10th + YAMHILL SMART PARK

LAND USE HEARING LU17-222650 DESIGN COMMISSION HEARING

10th and Yamhill Smart Park | LAND USE HEARING PRESENTATION LU 17-222650

Elevation at elevator lobby landing

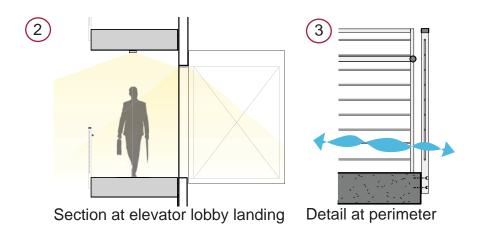
- There was appreciation for the restoration and integration of the wood soffit into the elevator lobby with the existing arcades, there was a concern for lighting this surface.
- Positive reaction was expressed for the creation of a more open stair and elevator, one member brought up a concern for wet landings.

1 To ensure that the upper level circulation areas are well lit, surface mounted round light fixtures are located on the underside of concrete stair landings, on the underside of the metal deck at the elevator lobby, and a linear fixture at the head of the elevator door threshold.

2 To address the concern for wet landings the design team studied possible solutions to shield the stair and elevator landings from the elements yet these solutions will cause bigger concerns as this will, in turn, create a space that will be too enclosed and therefore feel unsafe. The new design creates an open edge around all sides of the landings and stairs with an open cable railing, providing greater ability to drain and air dry unlike the current design whose solid concrete guardrails limits air movement and delays drying.
